Addendum # 1

Bid Opportunity: 26-7862-RFT - Trillium Public School Office Renovation

RE: Trillium PS Administration Office Reno
Kitchener, ON

ADDENDUM 01

E2.1

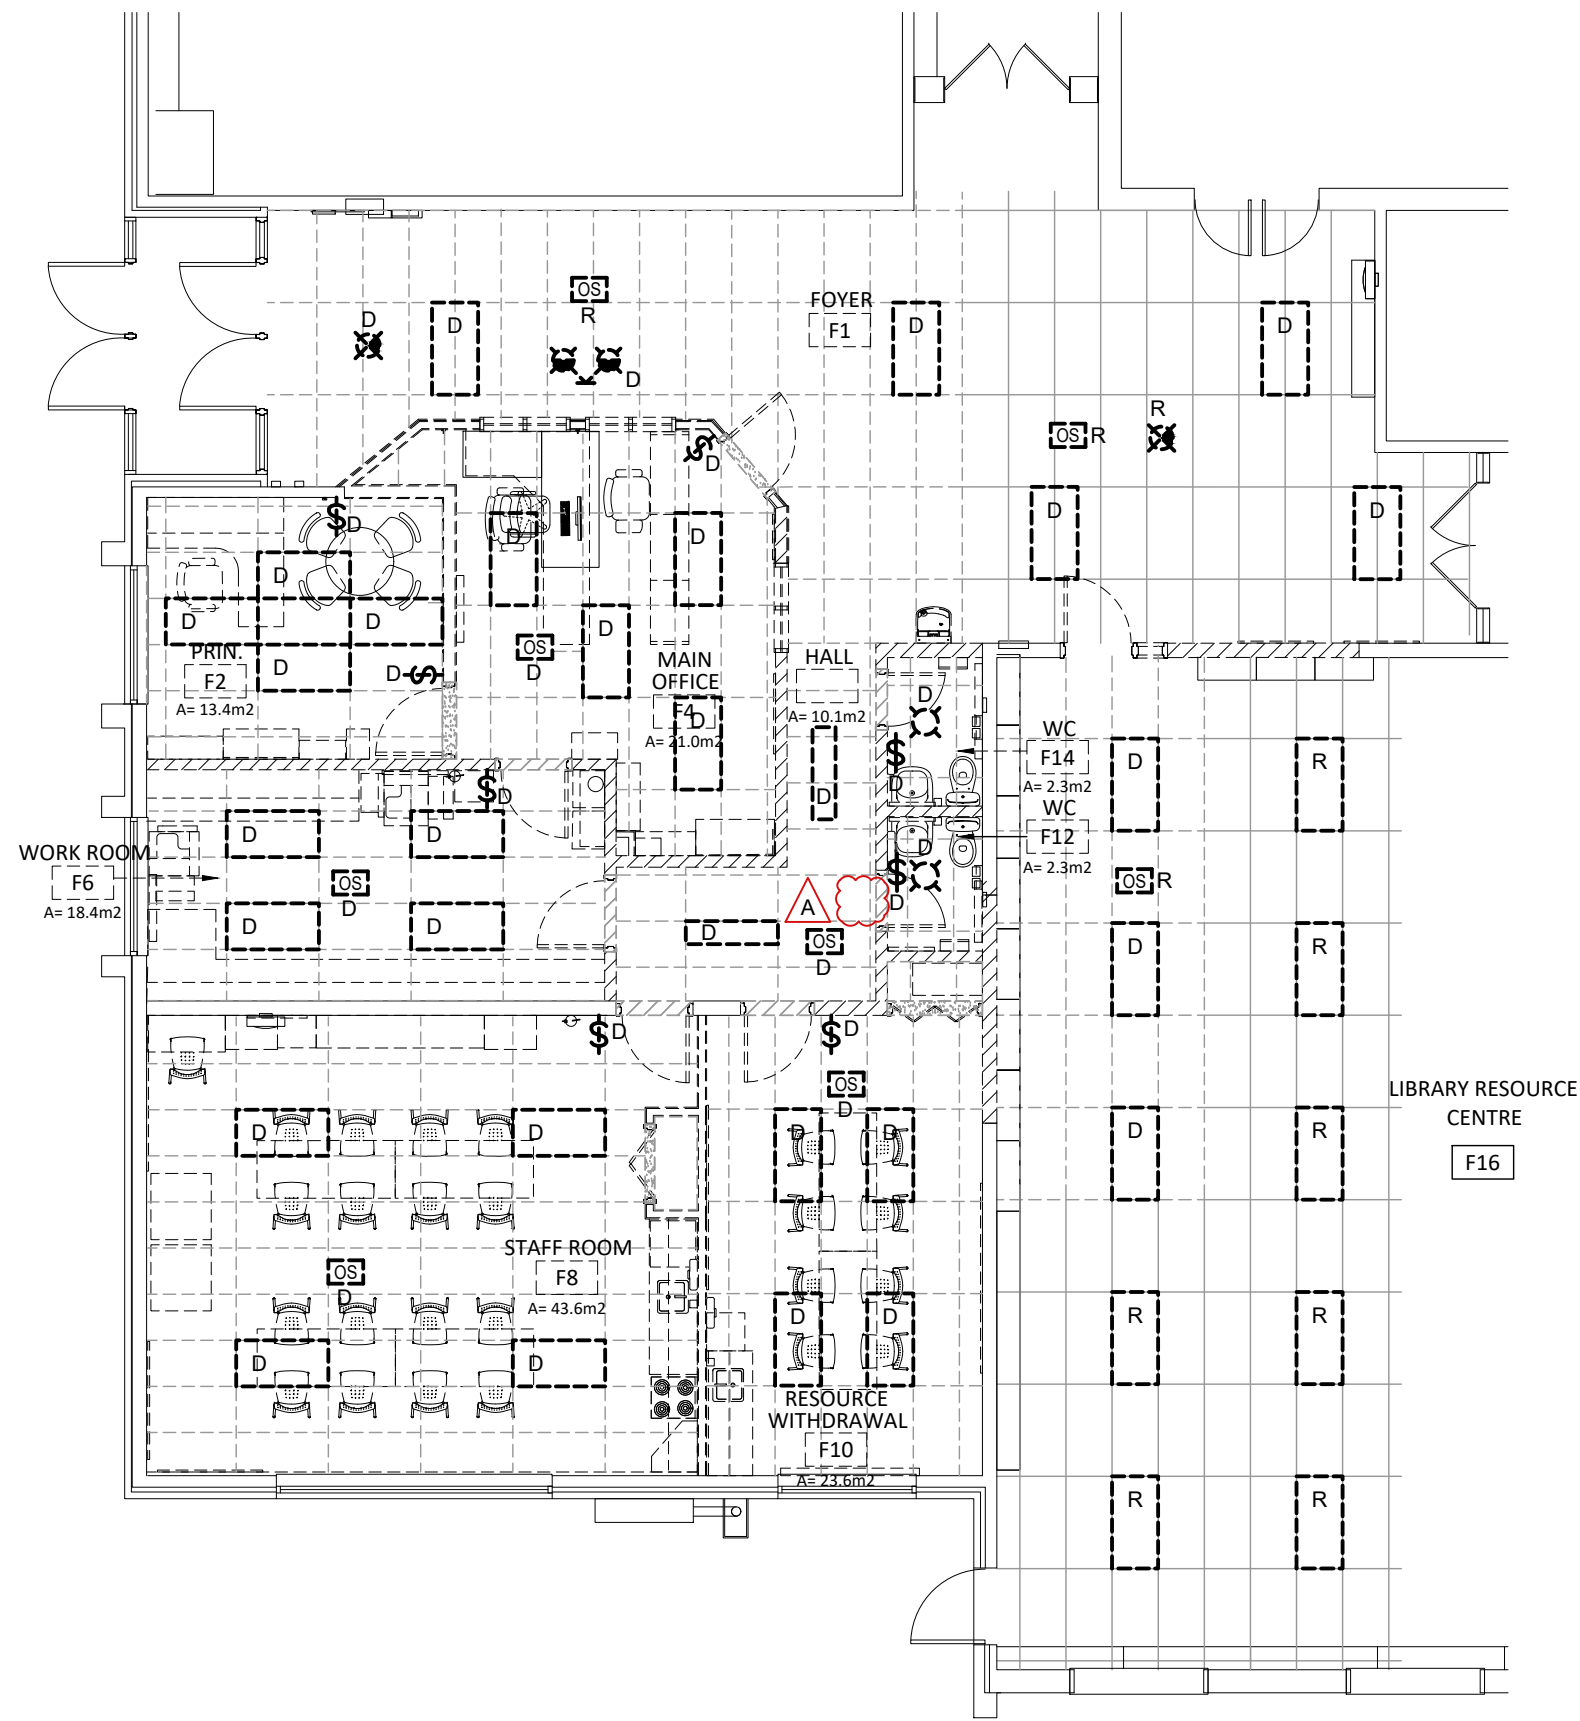
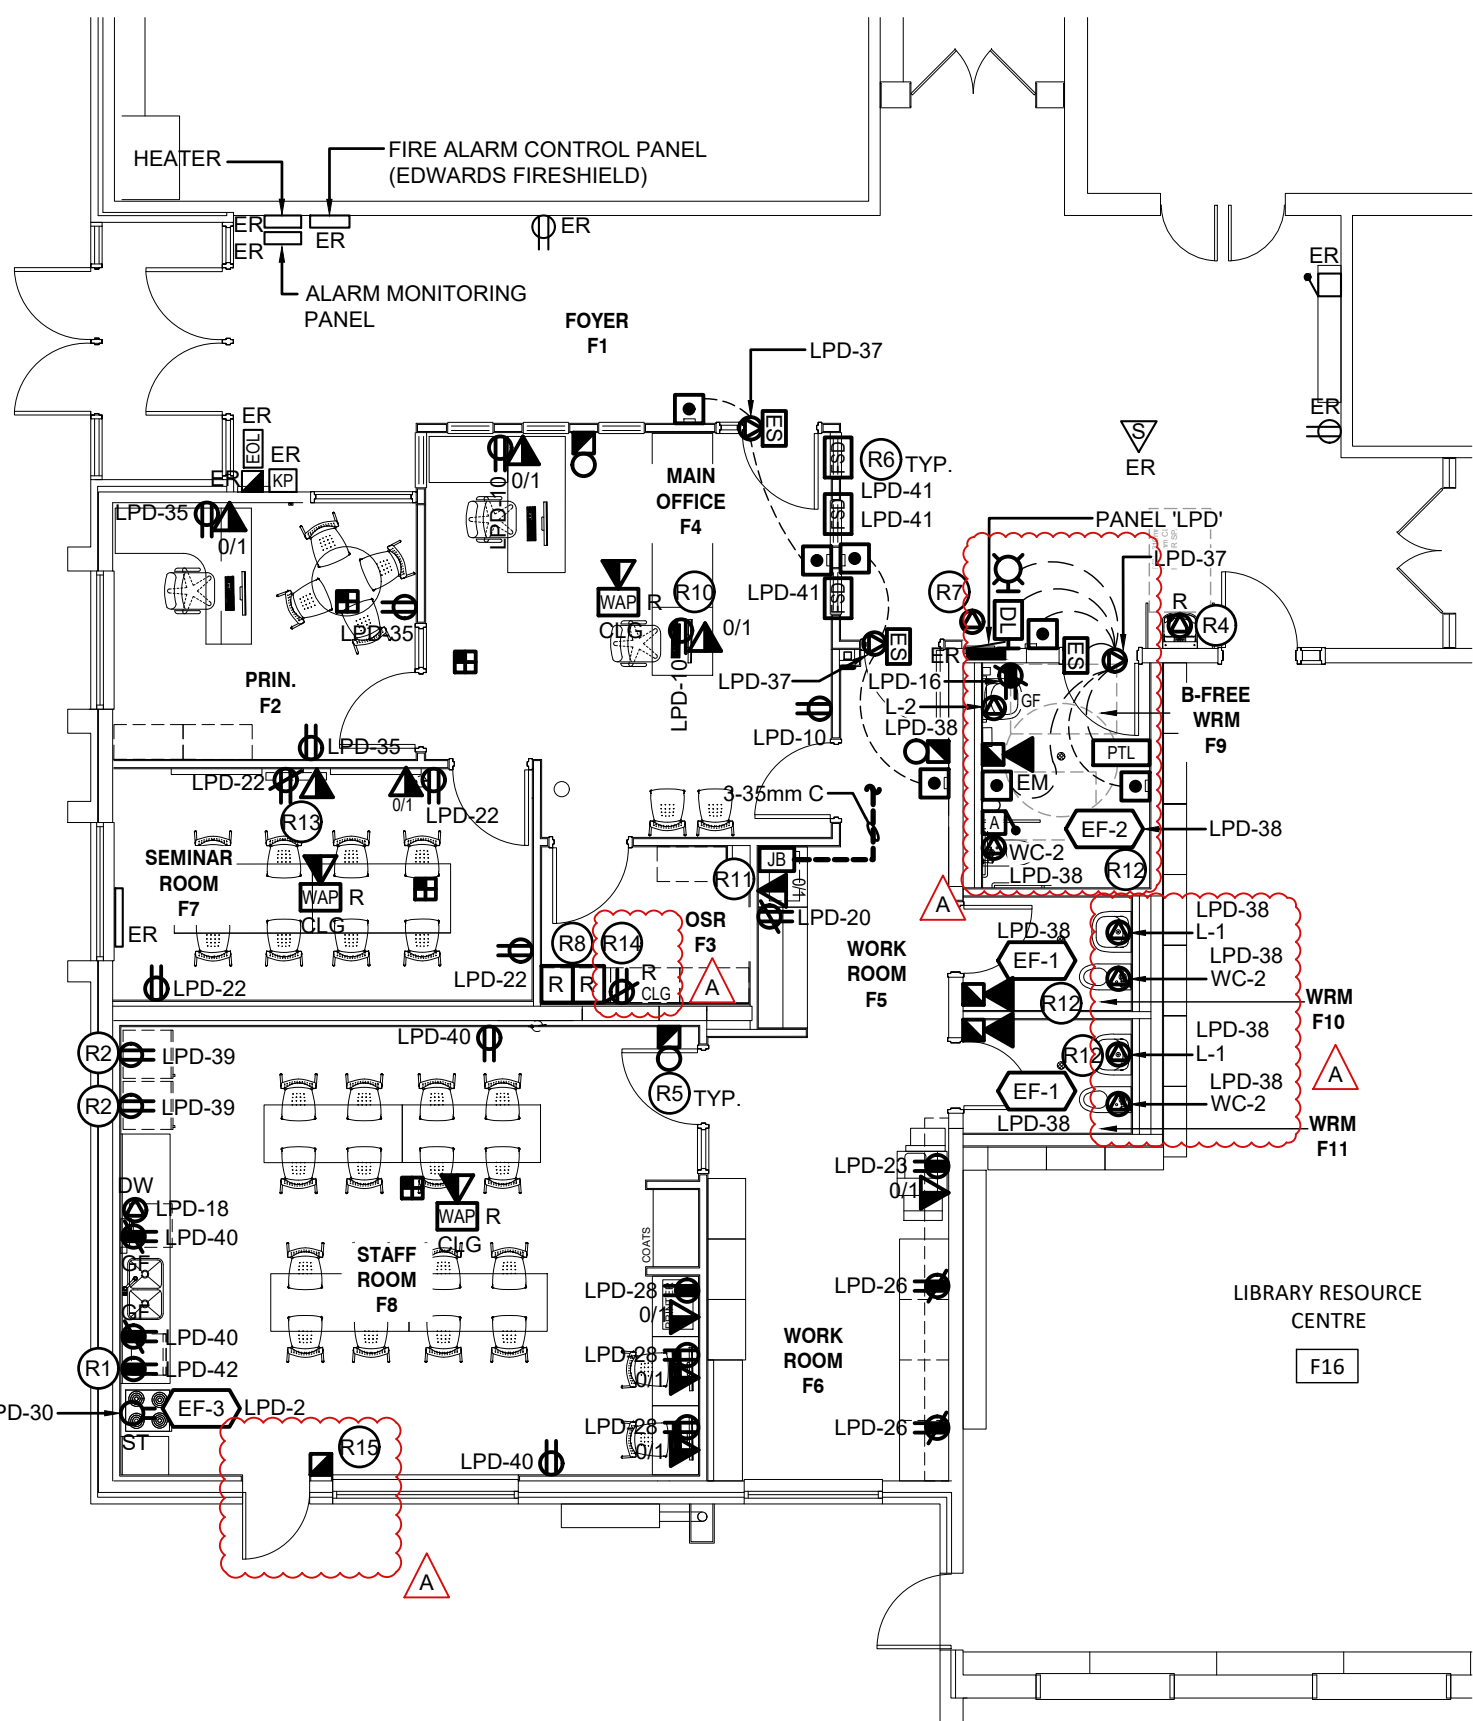
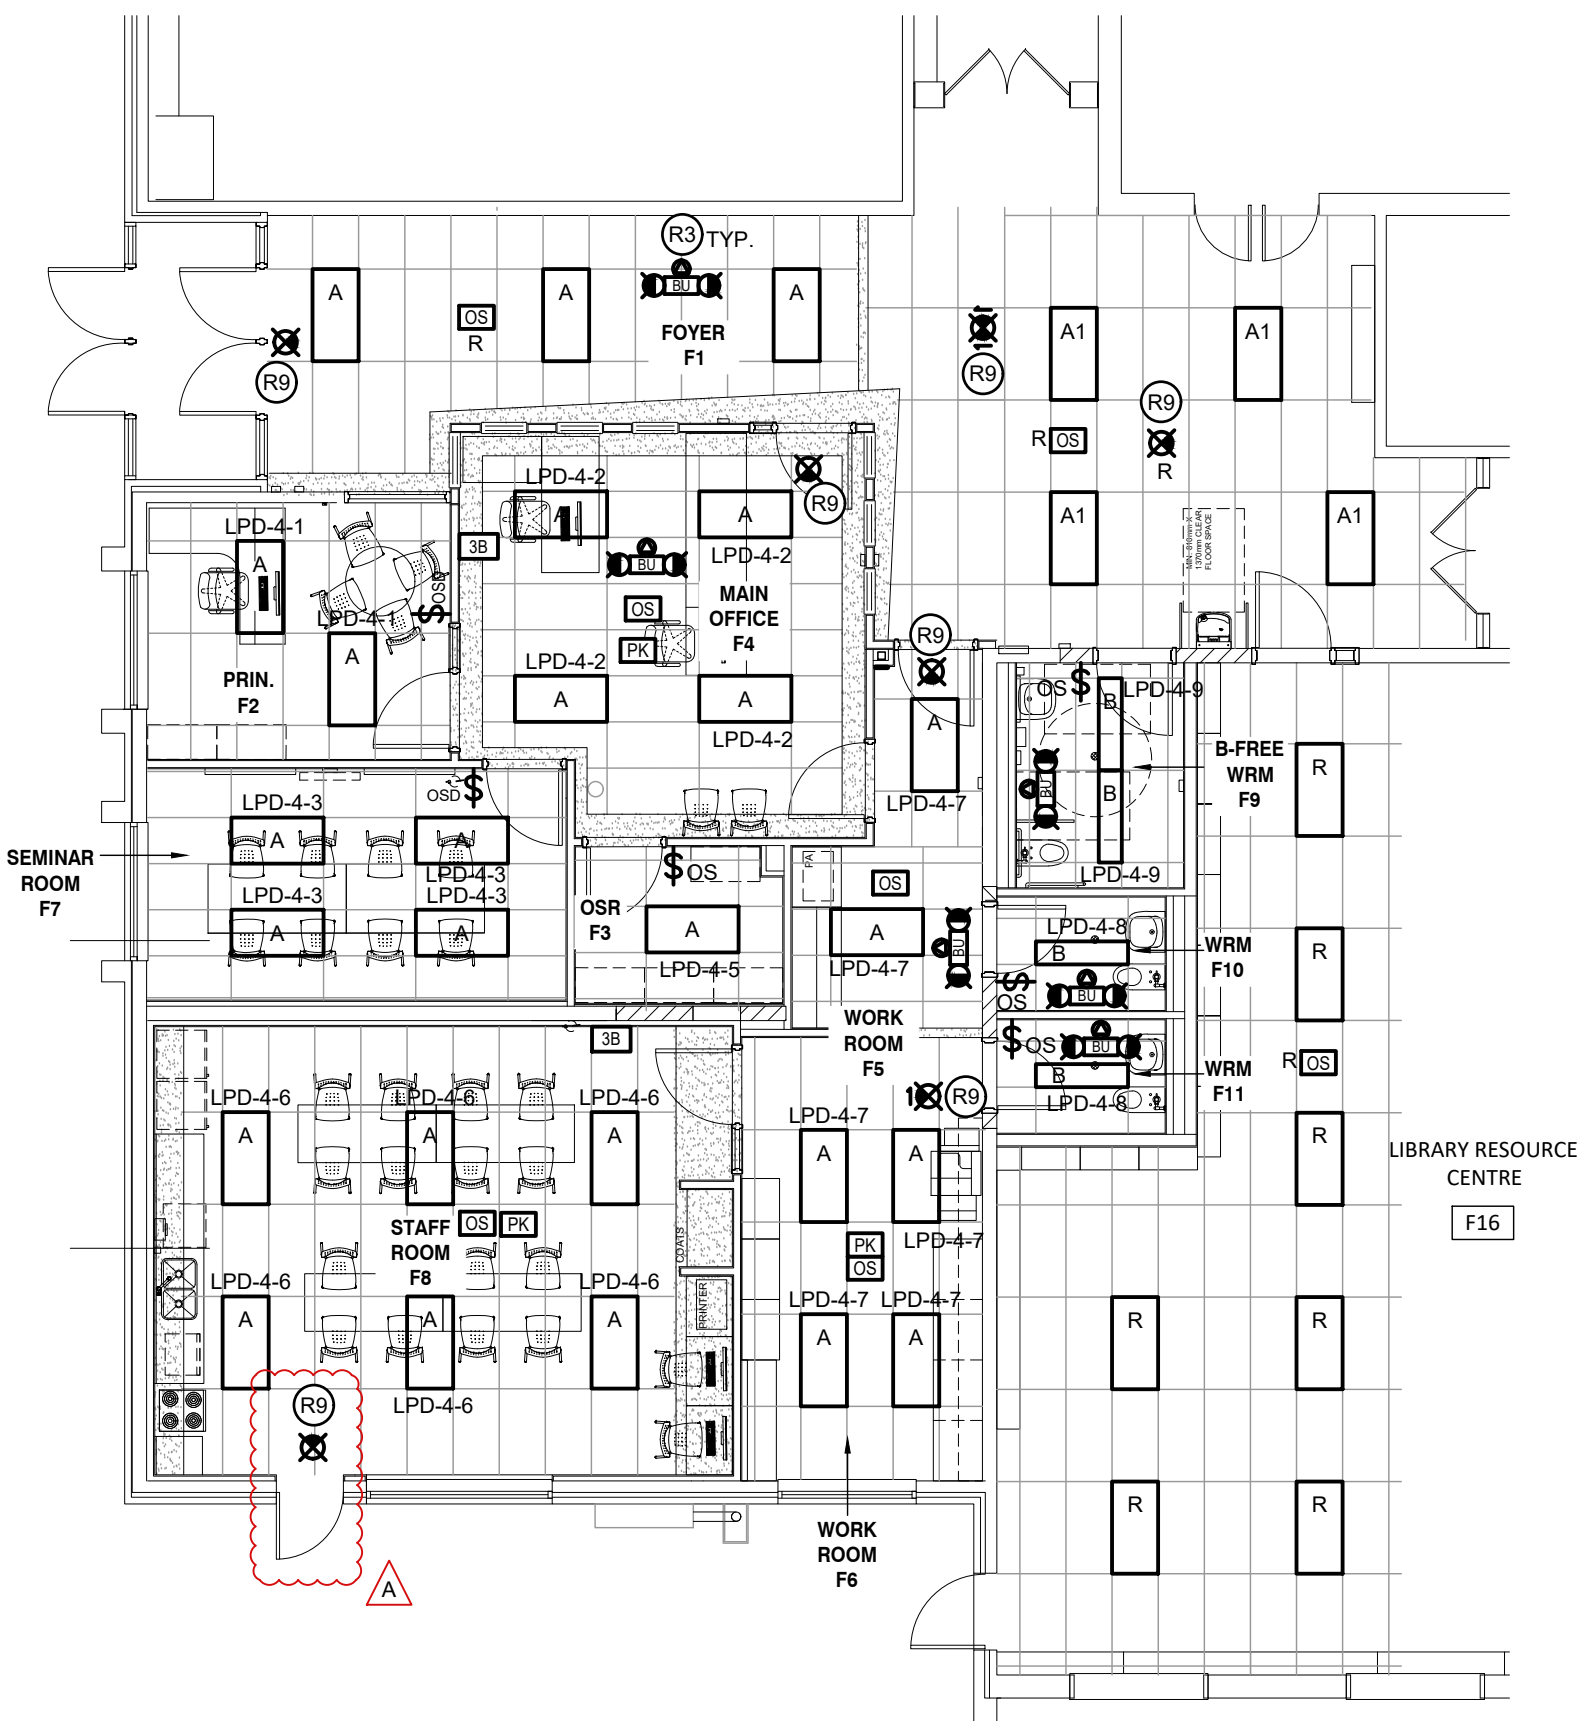
- 2.0 Reference Attached Reissued Drawing E2.1
 - .1 Indicated existing hardwired clocks are to be removed completely. See attached reissued drawing E2.1 for additional information.

- .2 Additional power devices for demolition include:
 - .1 Main Office F4: Two receptacles in millwork to be removed completely.
 - .2 Library Resource Centre F16: One receptacle and conduit to be removed completely.

- .3 Work Room F6: One voice/data outlet to be removed completely.
 - .3 One receptacle in Foyer F1 has been revised to remain.
 - .4 One non-existent light switch in the hall below Foyer F1 has been removed from the drawing.

- .5 For B-Free Washroom F9 renovation:
 - .1 Push to lock button has been added.
 - .2 Electric strike has been added.
 - .3 Occupied indication lighting has been added.Connections are to be completed as shown on attached reissued drawing E2.1.

- .6 Two hardwire connections for plumbing devices have been added to the renovation plan for Washroom F10 and F11. Connections are to be completed as shown on attached reissued drawing E2.1.

- .7 Indicated receptacle in the OSR F3 area is to be mounted at a high level.
- .8 New emergency door has been added to Staff Room F8. New renovations include one pull station and one exit sign in the staff room.
